RATTLING NOISE PERCEPTIBLE IN VEHICLE INTERIOR WITH AC ACTIVATED

This Service Information Bulletin (Revision 2) replaces SI B64 05 21 **dated April 2022**.

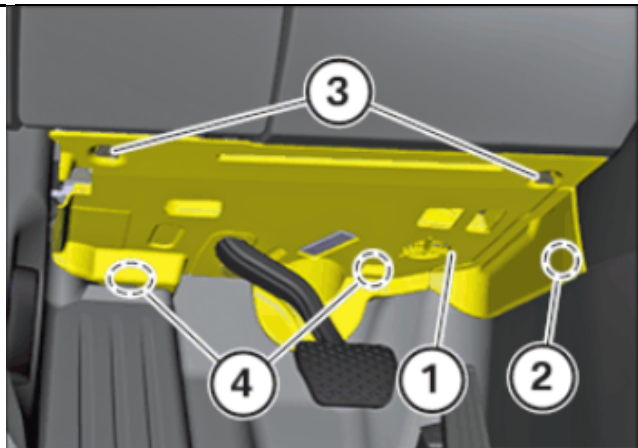
The refrigerant line double pipe and a clamp on the return line of the internal heat exchanger are in line with each other (in the direction of travel, on the left (driver) side of the engine compartment below/behind the DME) and are making contact.

<p>The hoses are contacting here (arrow).</p>
	<p>Mount a spacer (part number 11 53 7 537 923) in the engine compartment between the coolant hose feed and coolant hose return. The coolant hoses have to be turned about 10 to 15 degrees in the direction of the bulkhead.</p>

Insert a spacer between the coolant hoses underhood, and strips of felt tape in the area of contact between lines below the instrument panel.
